Ref: FCC Class II Permissive change for FCC ID: 2BBYH-C1018

This is to request a Class II Permissive change for FCC ID: 2BBYH-C1018 originally granted on 2023-07-20 (date).

CW Watch S1变更前心率板
CW Watch S1 Pre-Modification Heart Rate Board

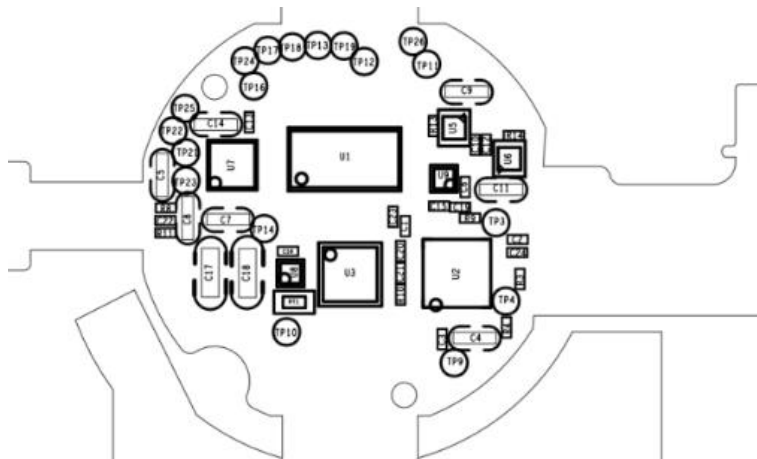
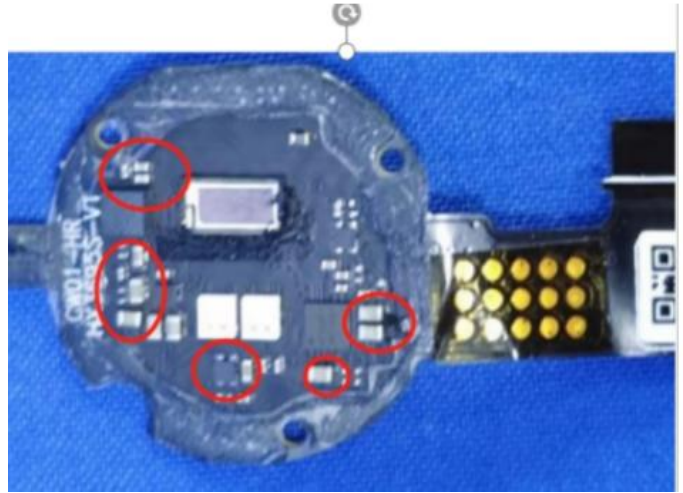
- 1, Heart rate board added program material IC.HX3695S, alternative program 1 material,
2. The heart rate board added D3 and D4 to replace the original U3.
